Ground Floor Strategy

Consented Scheme

Revised Scheme

Revised Scheme - Fourth Floor Plan

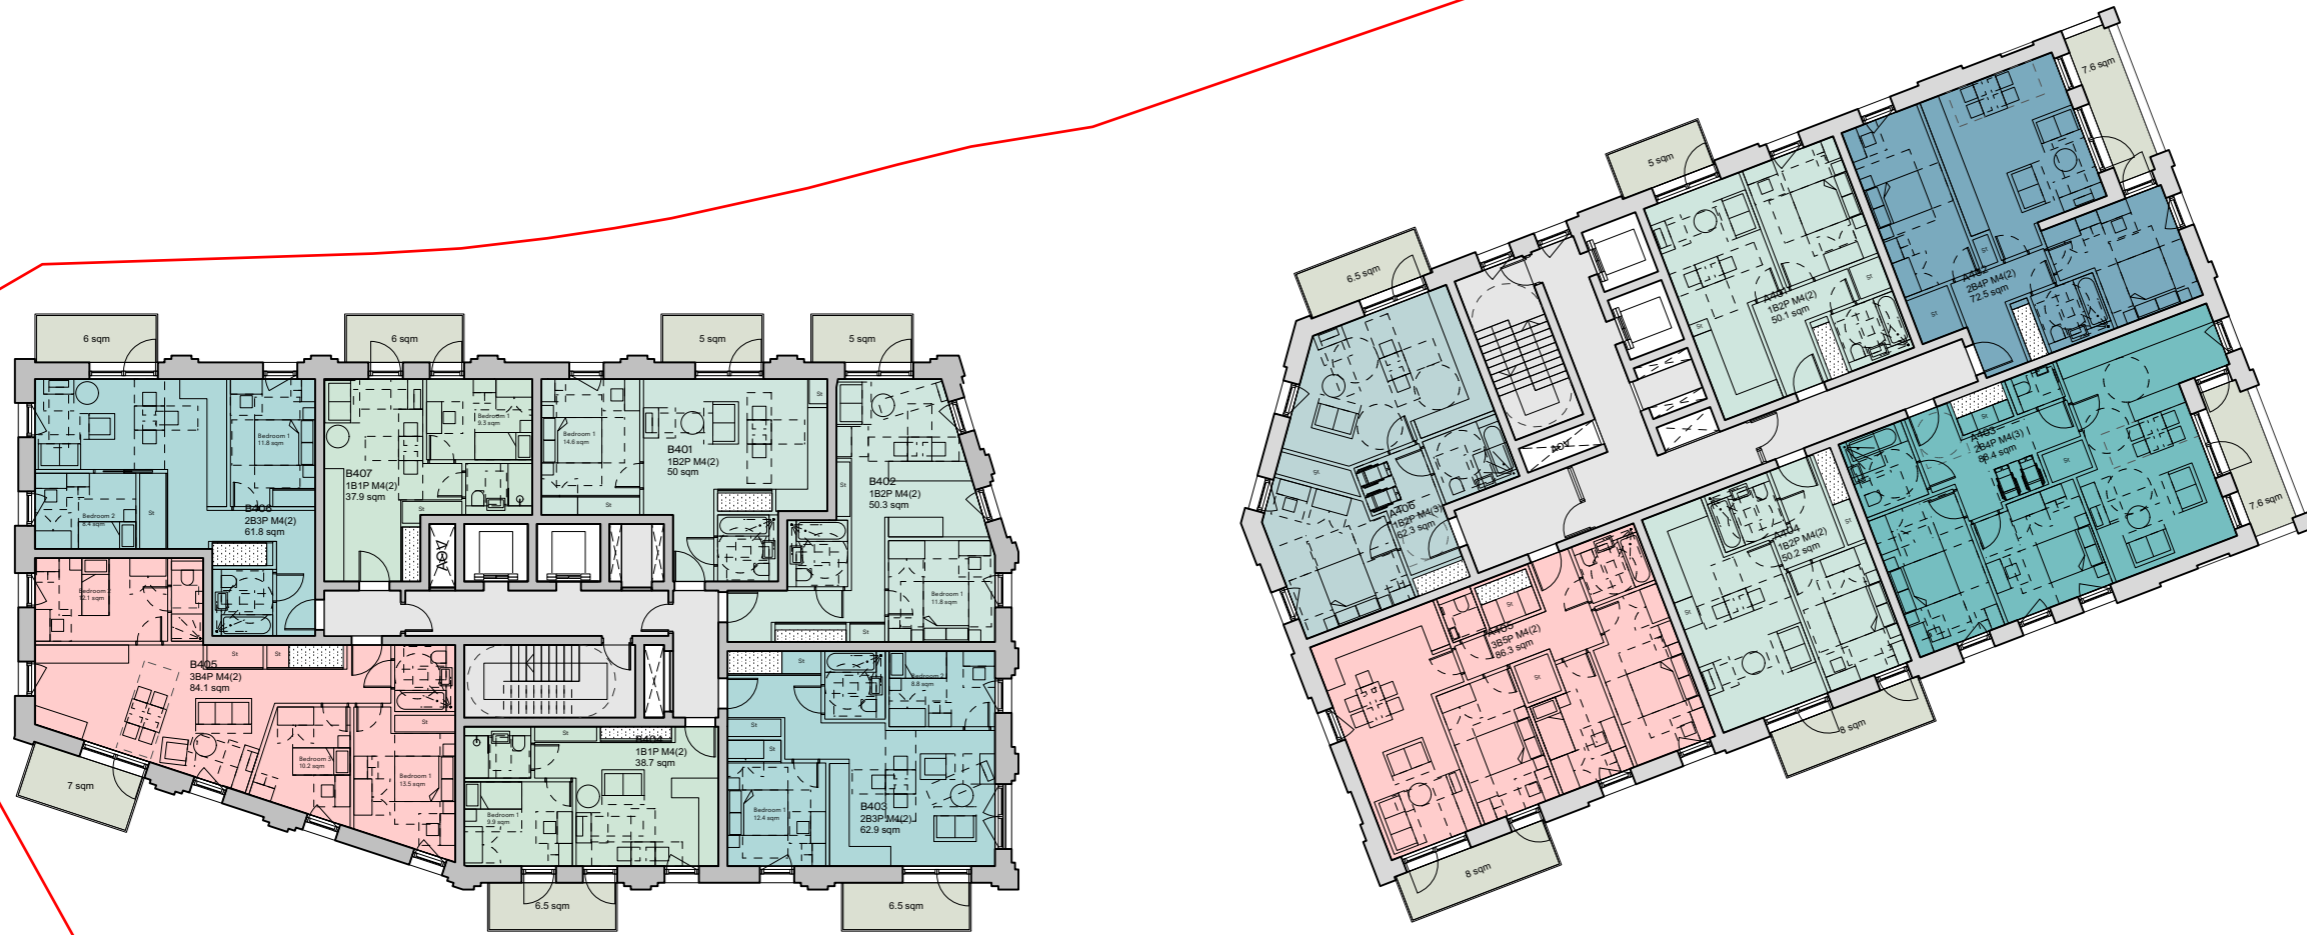
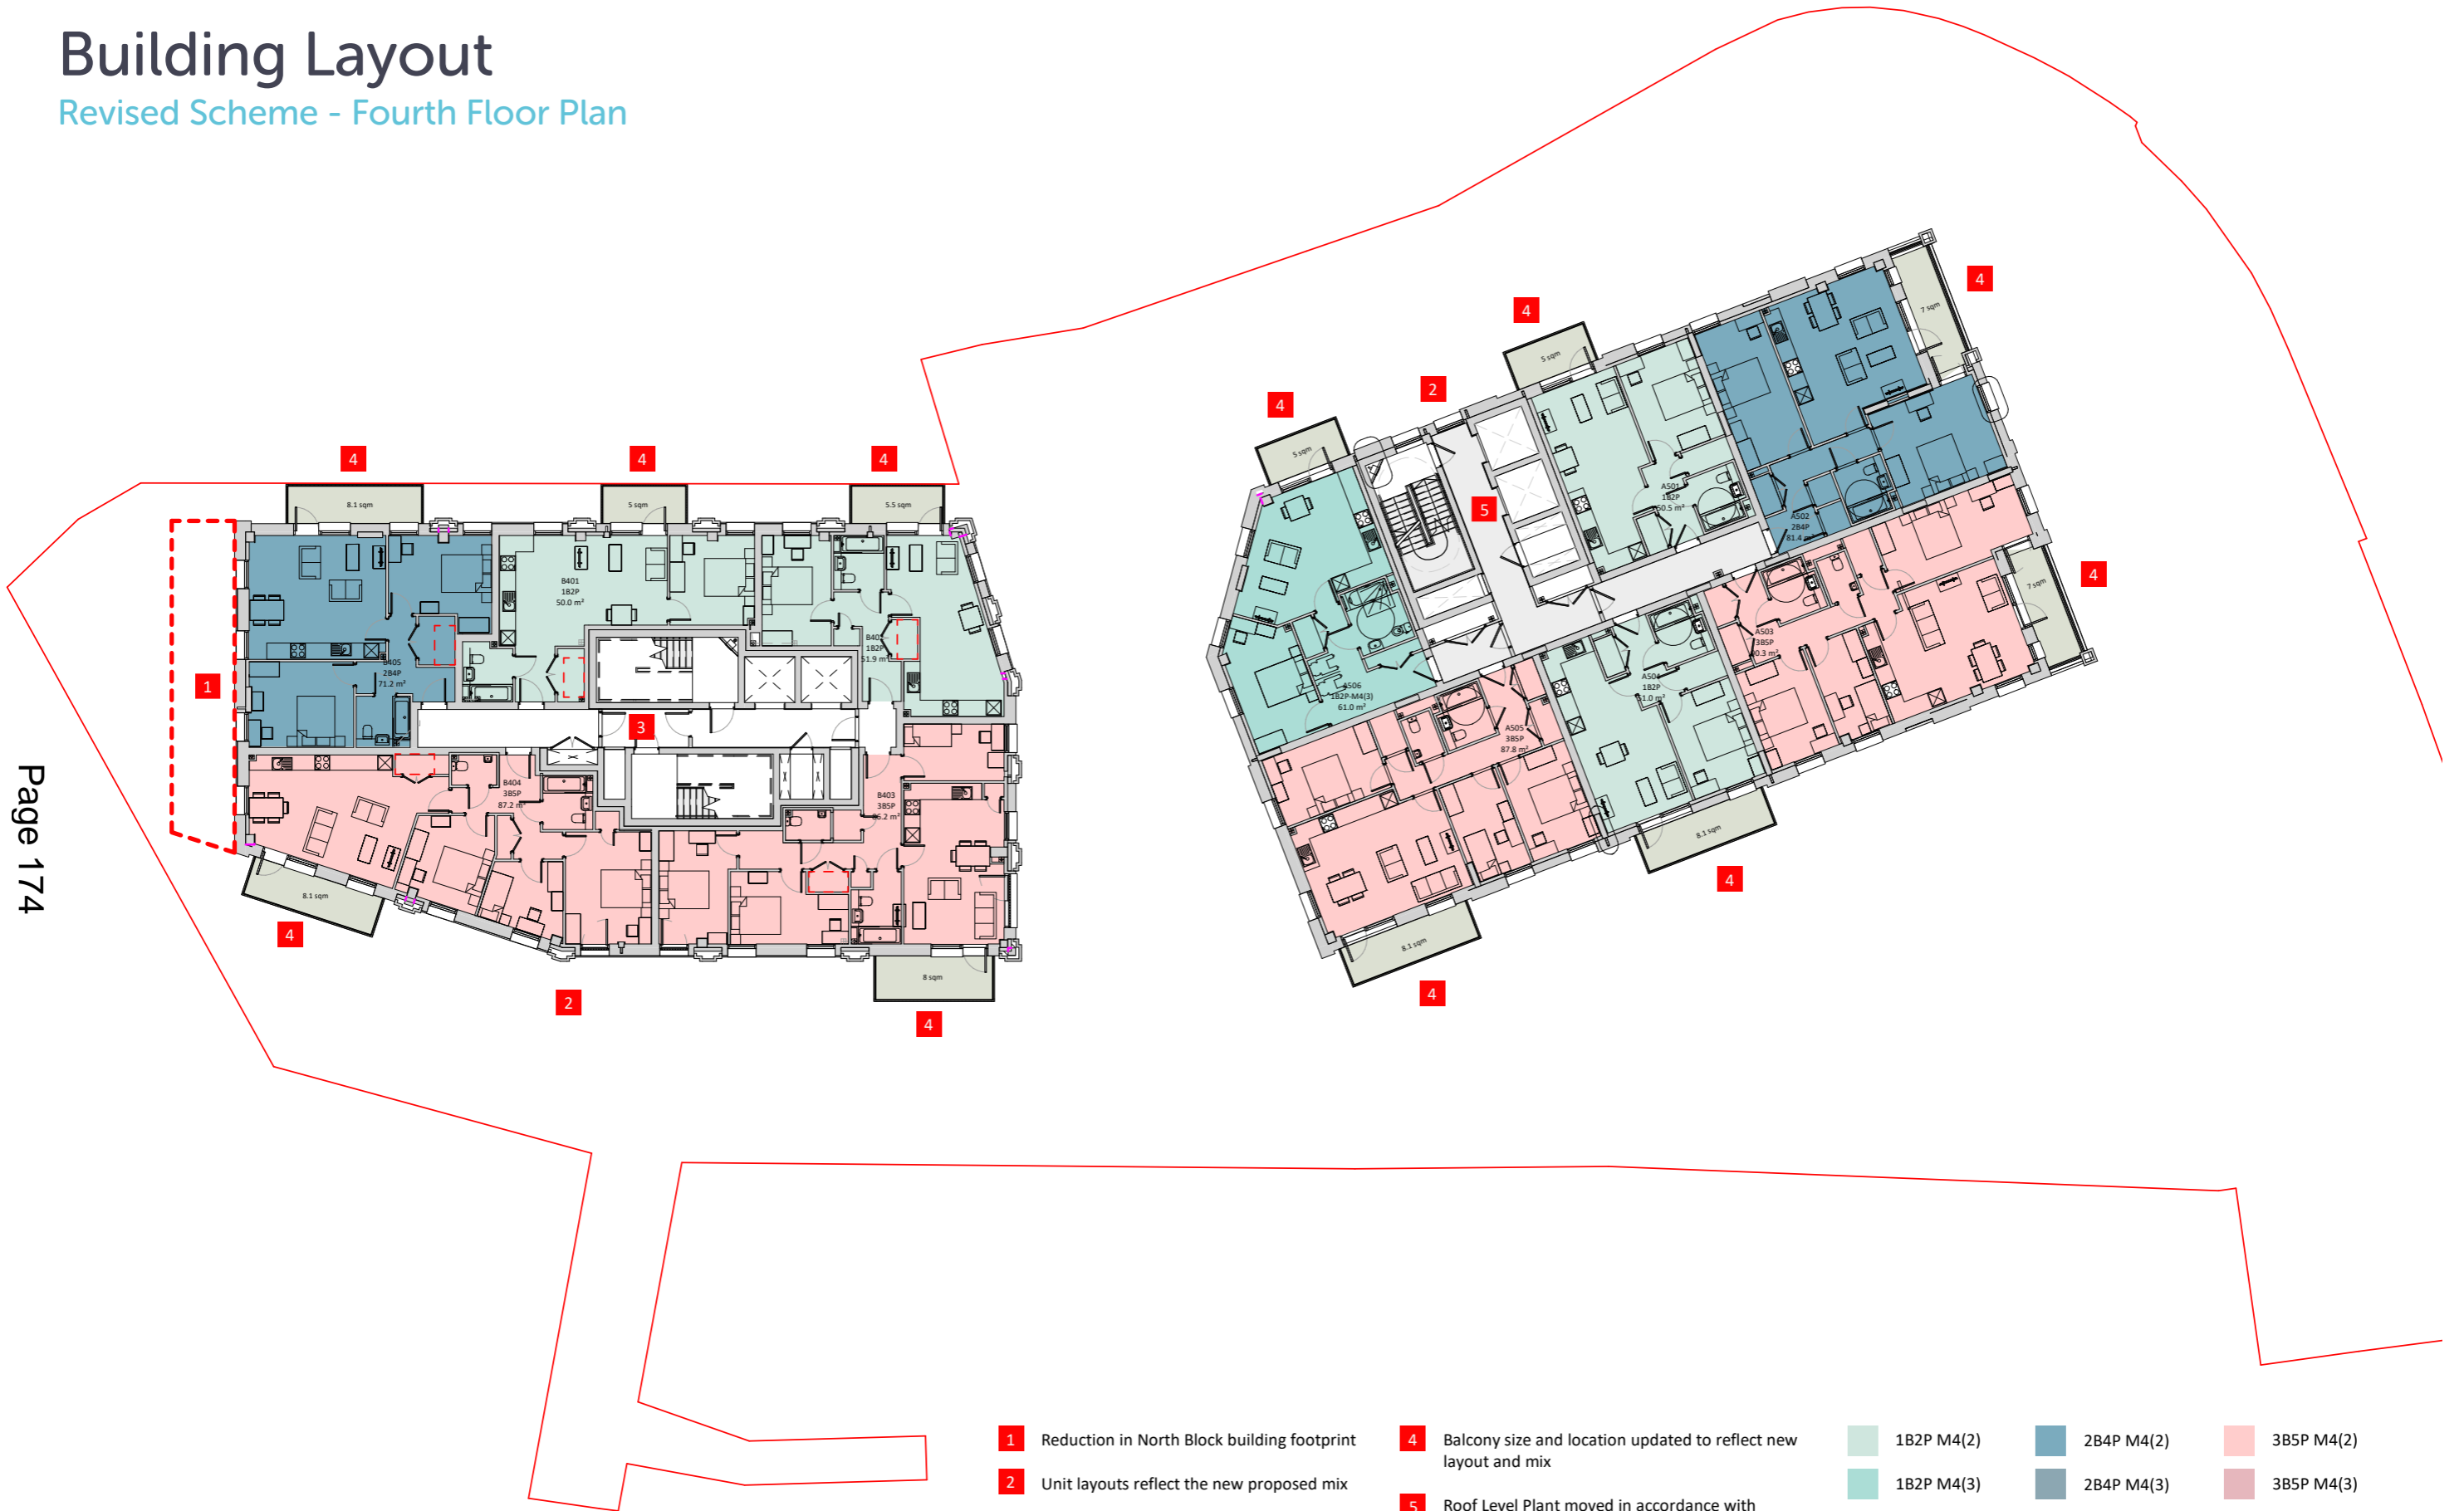
- 1 Reduction in North Block building footprint
 - 2 Unit layouts reflect the new proposed mix
 - 3 Revised core to accommodate secondary escape stair an additional vents and risers

- 4 Balcony size and location updated to reflect new layout and mix
 - 5 Roof Level Plant moved in accordance with below core shift
- | | | |
